ARCHITECT'S SUPPLEMENTAL INSTRUCTIONS

JONES GILLAM RENZ DOCUMENT JGR 710

PROJECT:	The Residence at Carter Lake New Development Carter Lake, IA	Report No.	Six (6)
OWNER:	OPG Carter Lake Partners, LLC Dan Maximuk 254 N. Santa Fe Ave, Suite A Salina, KS 67401	Date	February 19, 2026
CONTRACTOR:	Koester Construction Company 3050 SE Enterprise Dr. Grimes, IA 50111	Architect's Proj No.	25-3489
		Contract For:	General Construction Mechanical, Electrical

**THE RESIDENCE AT CARTER LAKE
ASI 6 - SUPPLEMENTAL DETAILS
CARTER LAKE, IOWA**

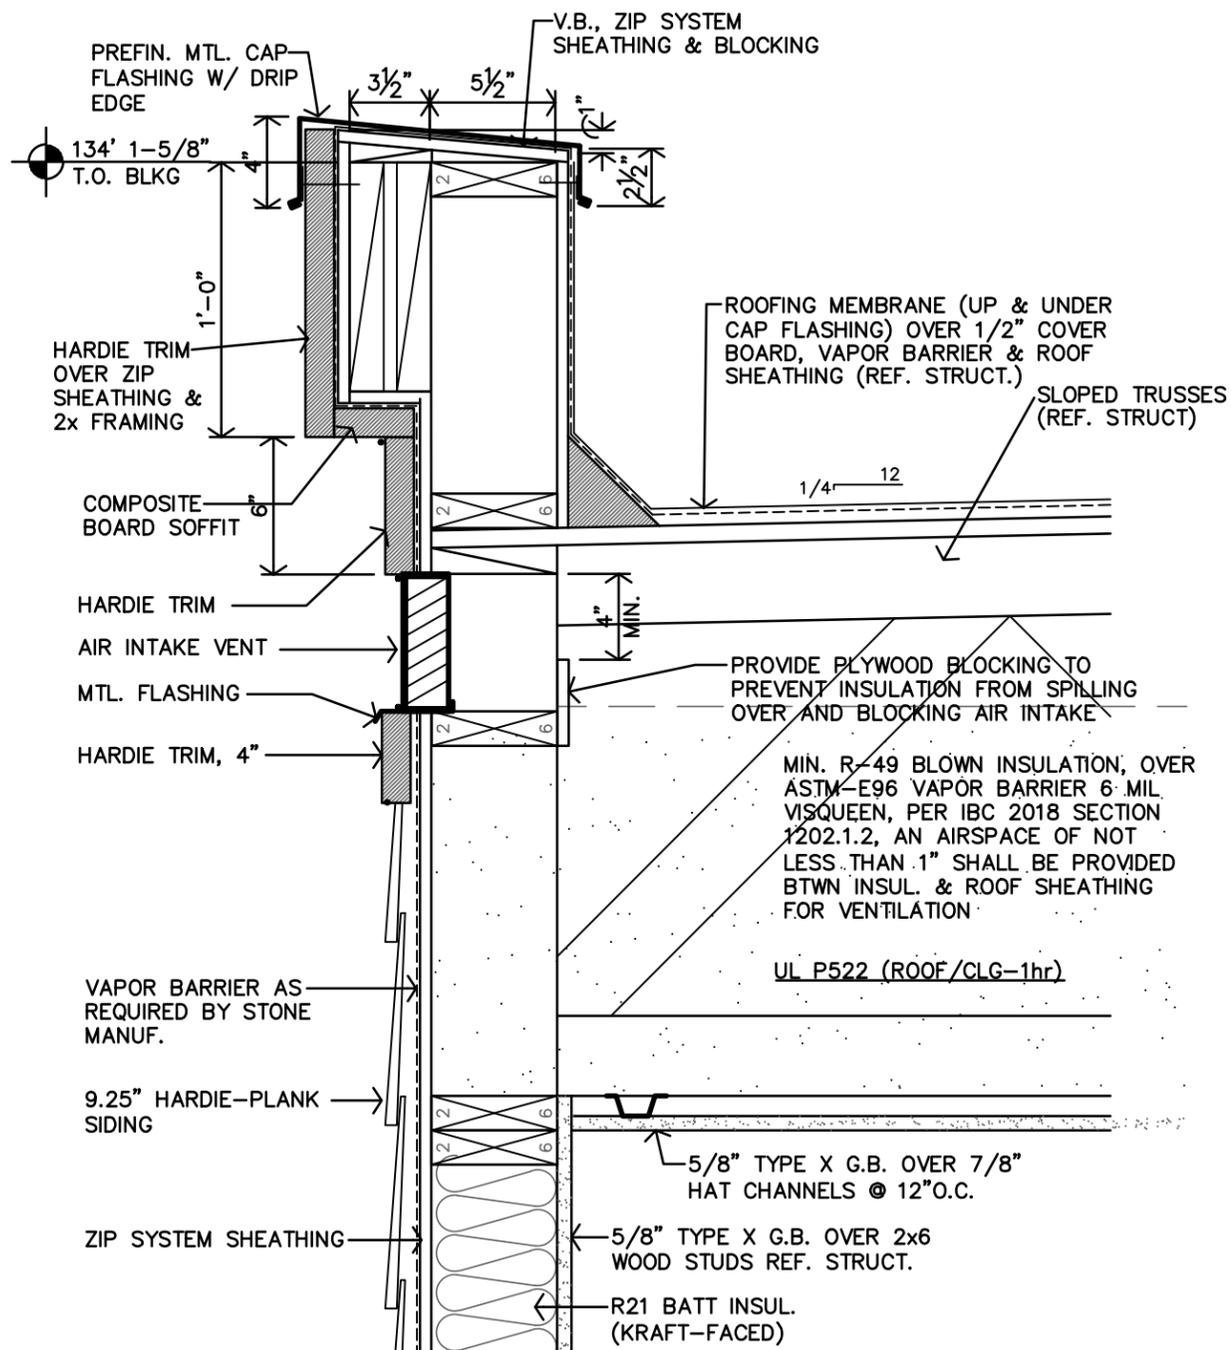
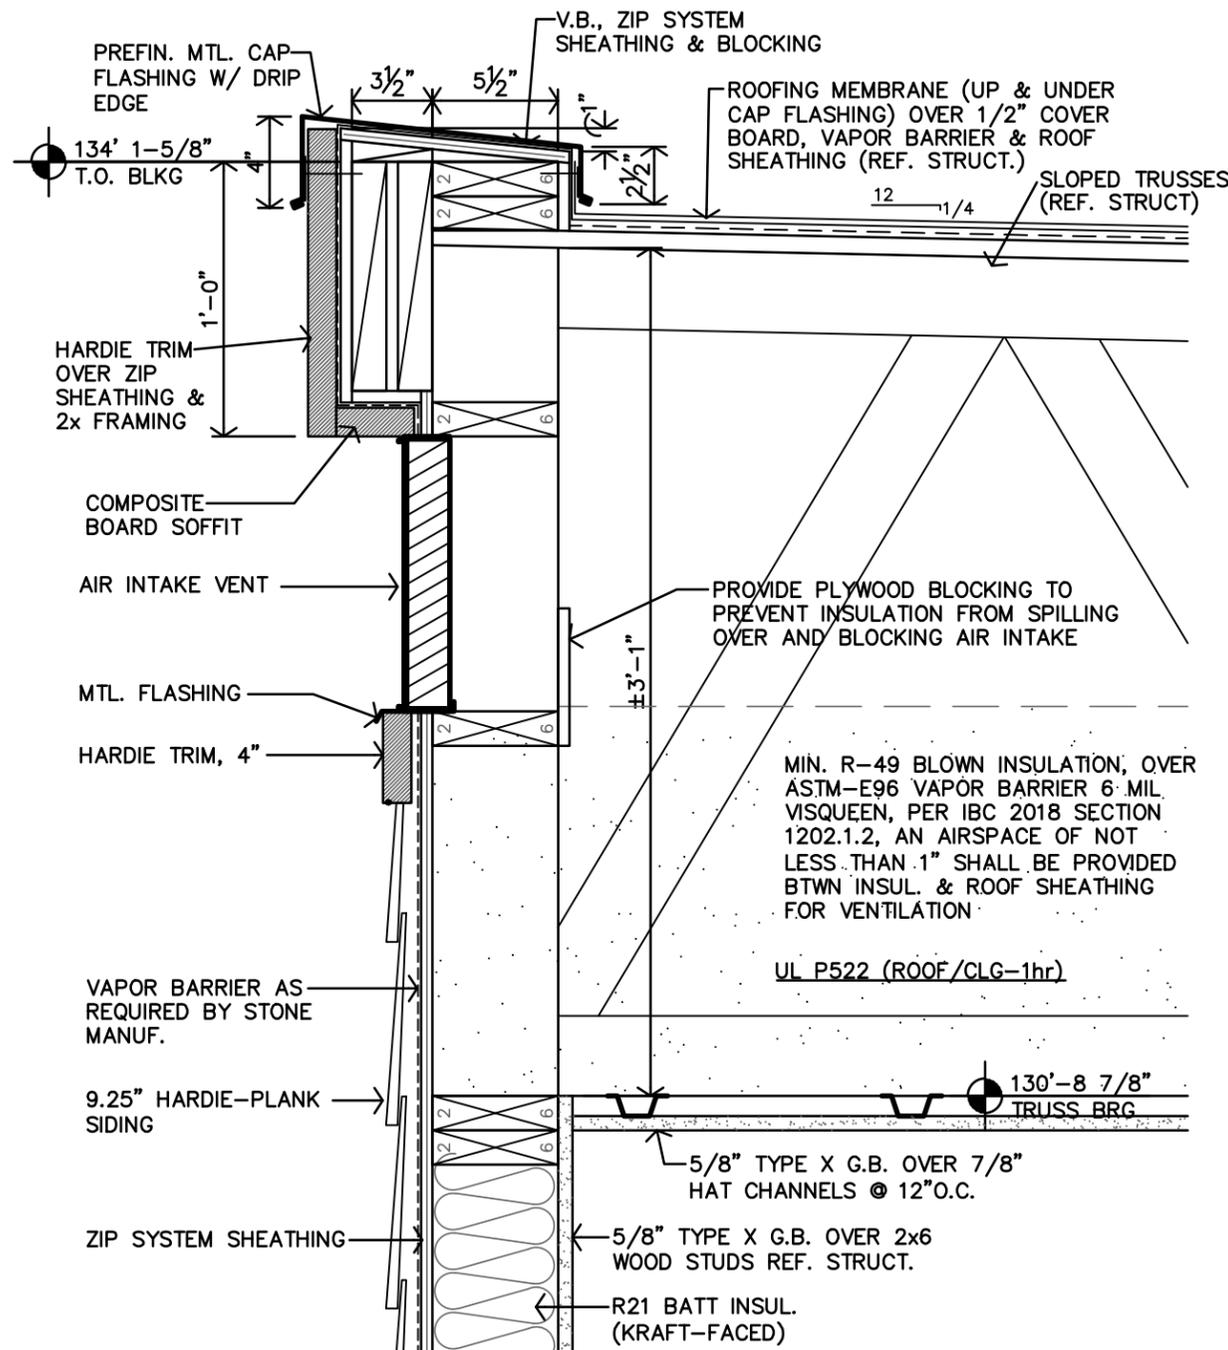
- 4) Supplemental Sheet A has been added with Details A & B showing the location of installation for the air louvers. Install air louvers per manufacturer's recommendations.

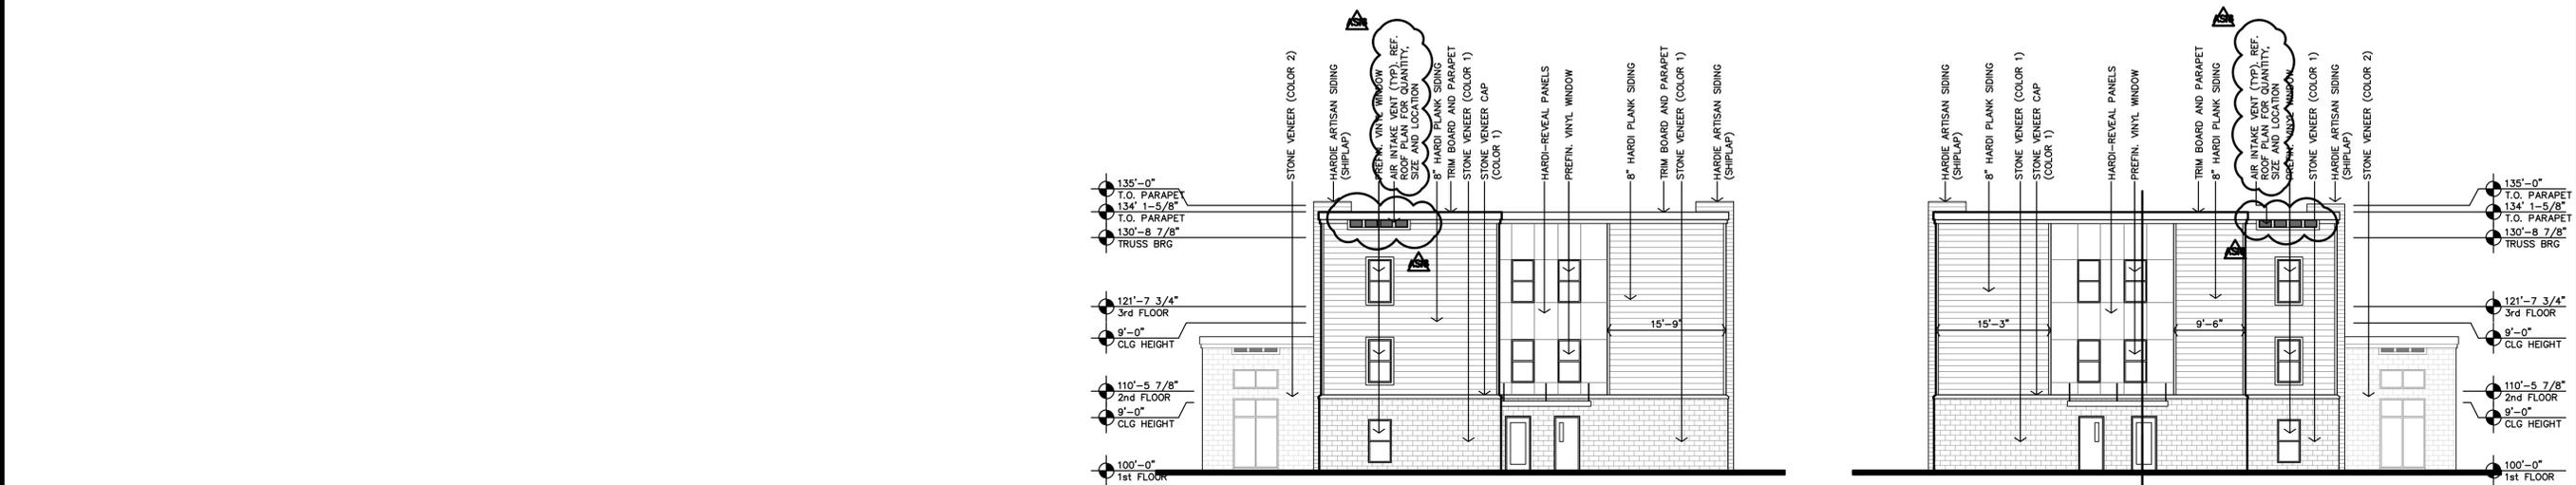
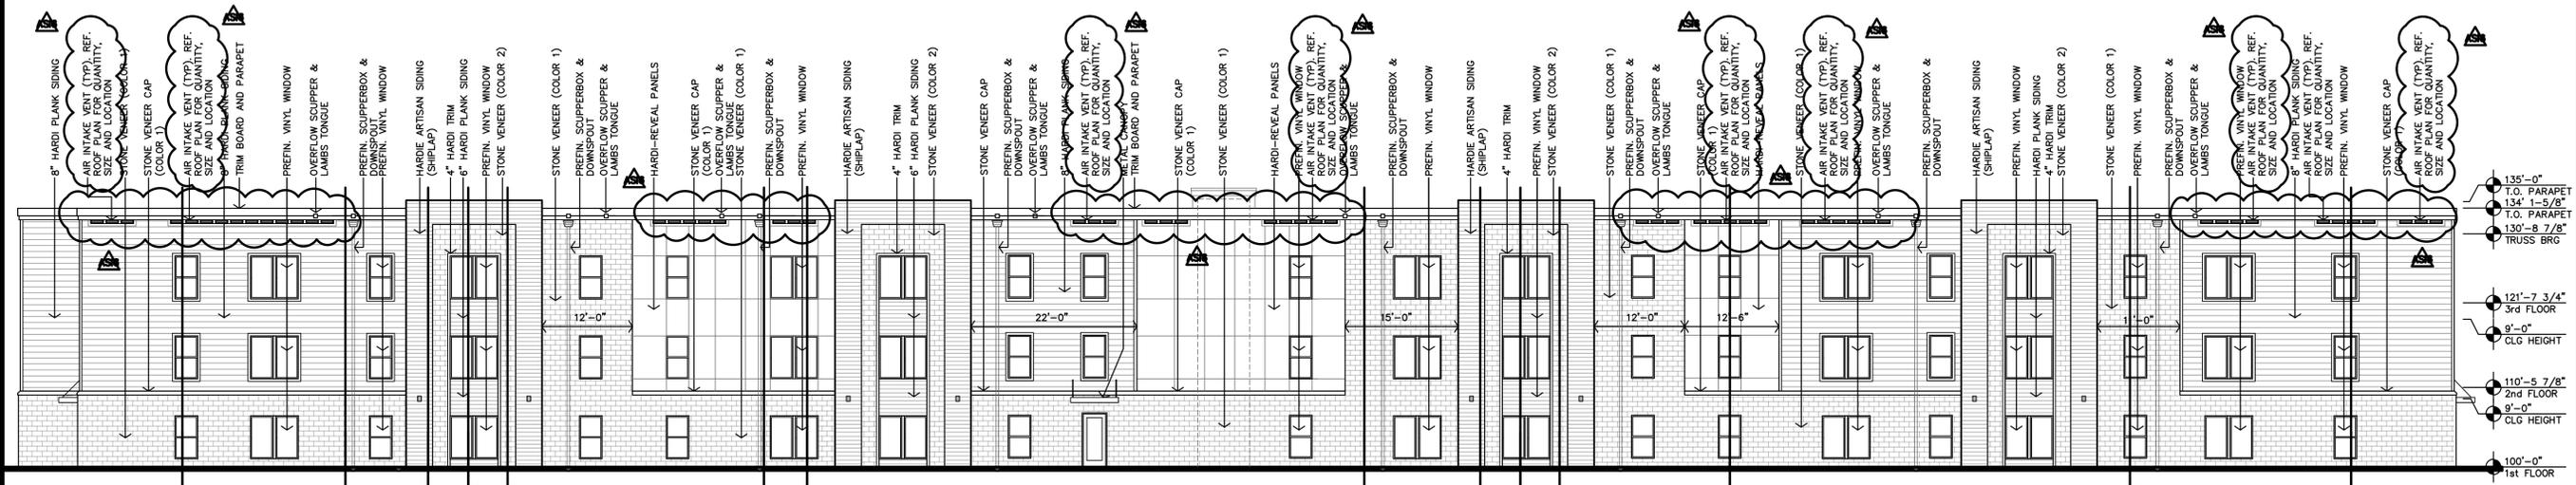
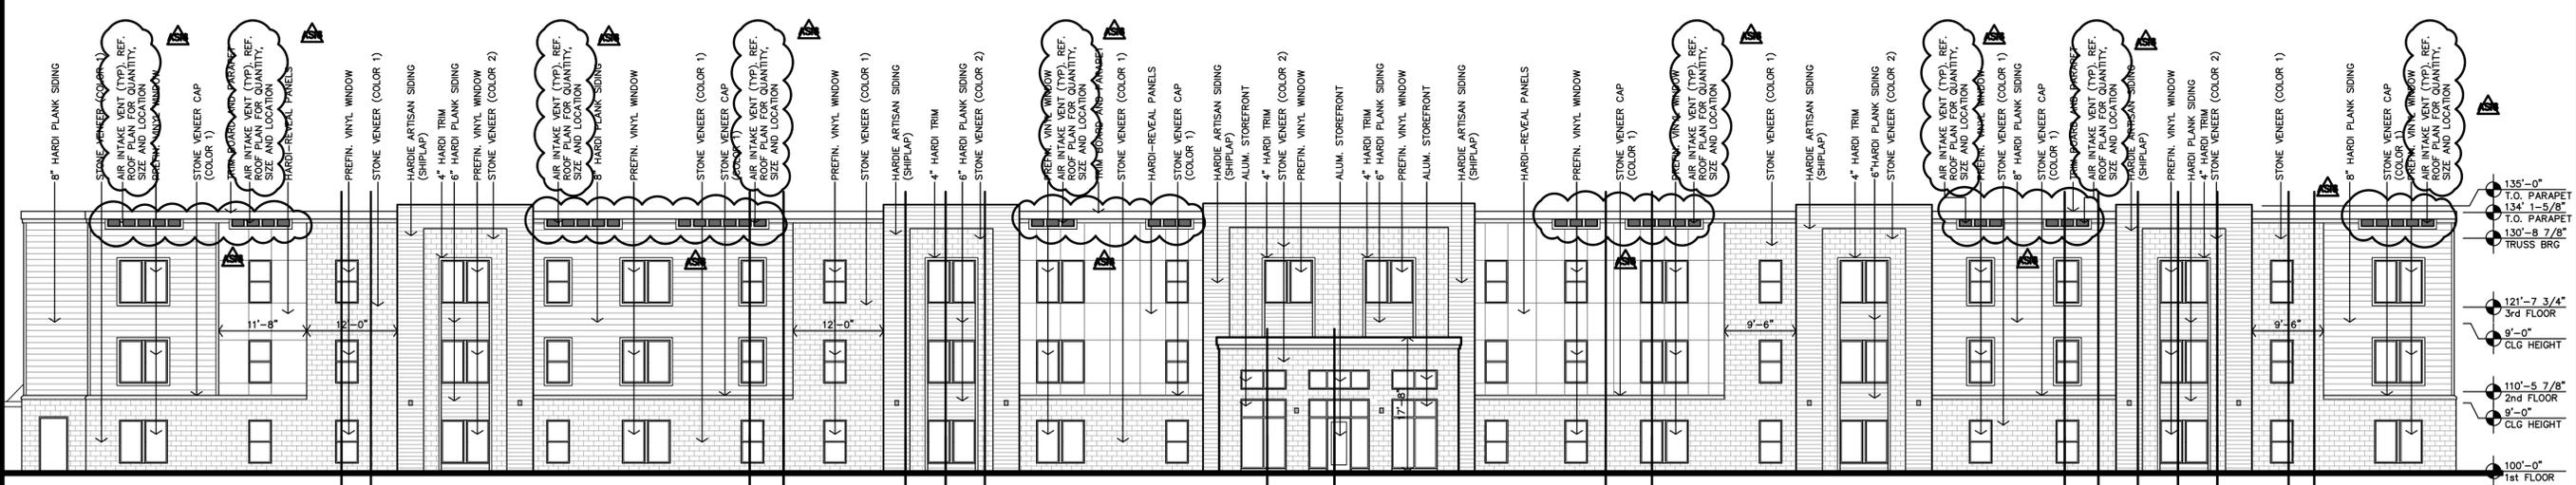
- 1) Install wind-driven rain louvers on exterior of building to increase air flow in attic space. Wind-driven rain louvers are to be Greenheck ESD-202 or equal produce (approved by architect) and shall provide a minimum airflow (NFA) as indicated on sheet A5.1. Size and location vary. Reference revised Sheets A5.1 and A7.1.

- AT WIND-DRIVEN RAIN LOUVERS, INSTALL IN-BETWEEN THE TRUSSES, AT THE TOP PORTION OF THE TRUSS SPACE IN ORDER TO AVOID CONFLICT WITH THE INSULATION BELOW. INSTALL 4" HARDI TRIM BOARD AROUND EACH GROUPING OF VENTS. LOCATIONS CAN SHIFT SLIGHTLY, DEPENDING ON FIELD CONDITIONS, AS LONG AS THE REQUIRED NUMBER OF VENTS ARE RETAINED IN THE ASSOCIATED DRAFTSTOP AREA.

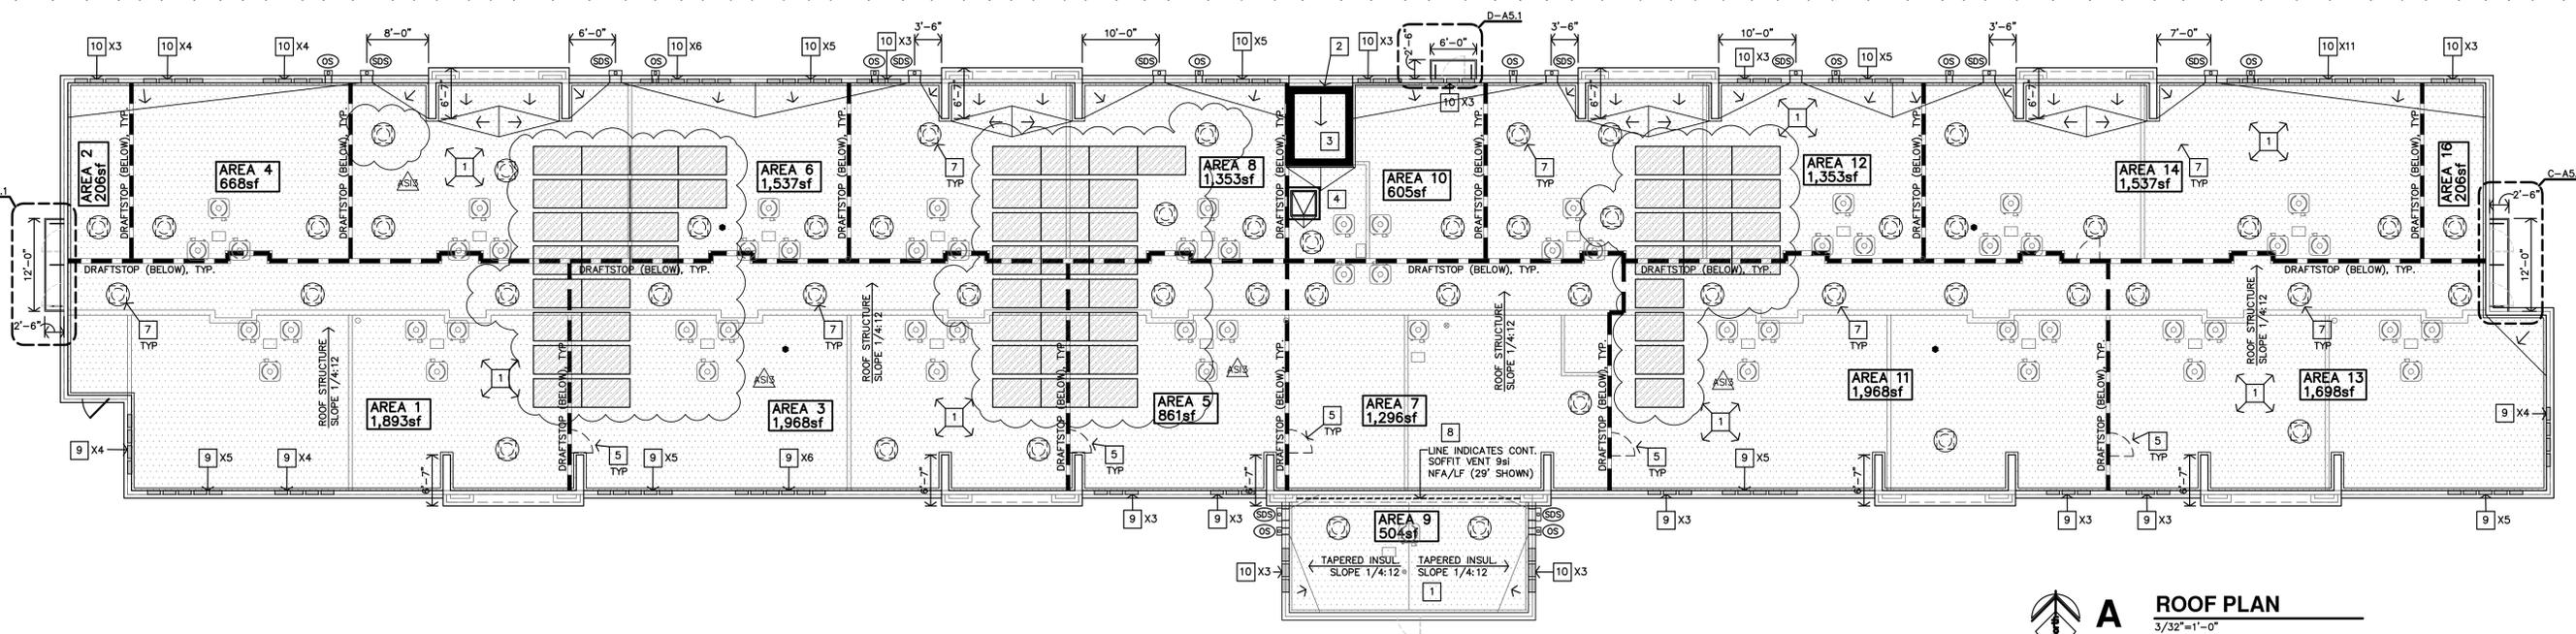
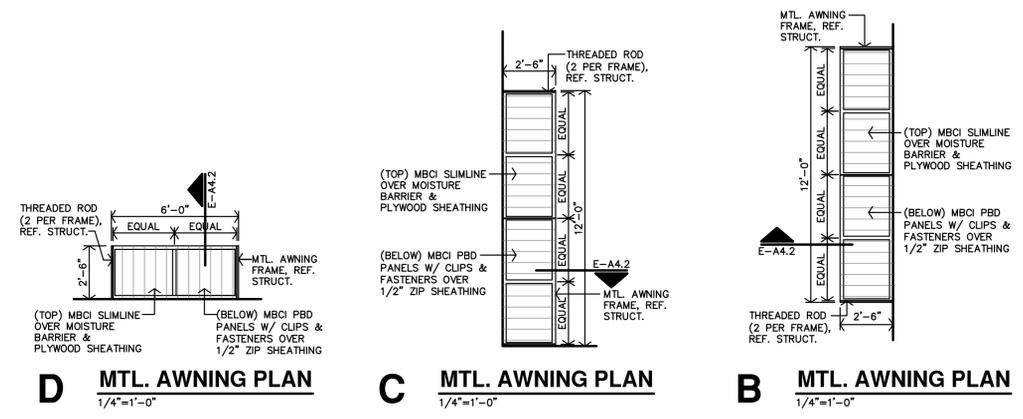
- 3) Roof top gravity ventilators have been reduced in number, reference 'Drafting stopping & Attic Ventilation' for amount and roof plan for location (A5.1).

- 6) Versico Roof Systems – TPO and PVC T-Top & Square Top Vents are approved for a VE option to the Greenheck Roof Gravity Ventilator products. NFA must either equal 1.83 sq ft (264 sq in) NFA or the proper number of roof vents will need to be provided and installed to meet the ventilations requirements as calculated on sheet A5.1

ROOF VENT 1 - GREENHECK GRAVITY VENTILATOR GRS-18-00 (1.83 SF OF NFA)	ROOF VENT 1 - GREENHECK RAIN LOUVER ESD-202 SIZE 12"x20" (0.42 SF OF NFA)	WALL VENT 1 - GREENHECK RAIN LOUVER ESD-202 SIZE 6"x20" (0.10 SF OF NFA)
AREA 1 (1,893 SF) 1,893/150 = 12.62 (of NFA VENTILATION REQ'D) (4) ROOF VENT 1 x 1.83 = 7.32 SF (13) WALL VENT 2 x 0.42 = 5.46 SF TOTAL NFA PROVIDED = 12.78 SF	AREA 6/14 (1,537 SF) 1,537/150 = 10.25 (of NFA VENTILATION REQ'D) (5) ROOF VENT 1 x 1.83 = 9.15 SF (13) WALL VENT 2 x 0.10 = 1.30 SF TOTAL NFA PROVIDED = 10.25 SF	AREA 2/16 (206 SF) 206/150 = 1.37 (of NFA VENTILATION REQ'D) (1) ROOF VENT 1 x 1.83 = 1.83 SF (3) WALL VENT 2 x 0.10 = 0.30 SF TOTAL NFA PROVIDED = 2.13 SF
AREA 3/11 (1,968 SF) 1,968/150 = 13.12 (of NFA VENTILATION REQ'D) (5) ROOF VENT 1 x 1.83 = 9.15 SF (11) WALL VENT 1 x 0.42 = 4.62 SF TOTAL NFA PROVIDED = 13.77 SF	AREA 7 (1,296 SF) 1,296/150 = 8.64 (of NFA VENTILATION REQ'D) (4) ROOF VENT 1 x 1.83 = 7.32 SF (29) SOFFIT VENT x 9sf = 261sf = 1.81 SF TOTAL NFA PROVIDED = 9.13 SF	AREA 8/12 (1,353 SF) 1,353/150 = 9.02 (of NFA VENTILATION REQ'D) (5) ROOF VENT 1 x 1.83 = 3.66 SF (8) WALL VENT 2 x 0.10 = 0.80 SF TOTAL NFA PROVIDED = 4.26 SF

AREA 4 (668 SF) 668/150 = 4.45 (of NFA VENTILATION REQ'D) (2) ROOF VENT 1 x 1.83 = 3.66 SF (3) WALL VENT 1 x 0.42 = 1.26 SF TOTAL NFA PROVIDED = 4.46 SF	AREA 9 (504 SF) 504/150 = 3.36 (of NFA VENTILATION REQ'D) (2) ROOF VENT 1 x 1.83 = 3.66 SF (6) WALL VENT 2 x 0.10 = 0.60 SF TOTAL NFA PROVIDED = 4.26 SF	AREA 10 (605 SF) 605/150 = 4.03 (of NFA VENTILATION REQ'D) (2) ROOF VENT 1 x 1.83 = 3.66 SF (3) WALL VENT 1 x 0.42 = 1.26 SF TOTAL NFA PROVIDED = 4.26 SF
AREA 5 (861 SF) 861/150 = 5.74 (of NFA VENTILATION REQ'D) (2) ROOF VENT 1 x 1.83 = 3.66 SF (3) WALL VENT 1 x 0.42 = 1.26 SF TOTAL NFA PROVIDED = 6.18 SF	AREA 13 (1,698 SF) 1,698/150 = 11.32 (of NFA VENTILATION REQ'D) (4) ROOF VENT 1 x 1.83 = 7.32 SF (11) WALL VENT 1 x 0.42 = 4.62 SF TOTAL NFA PROVIDED = 12.94 SF
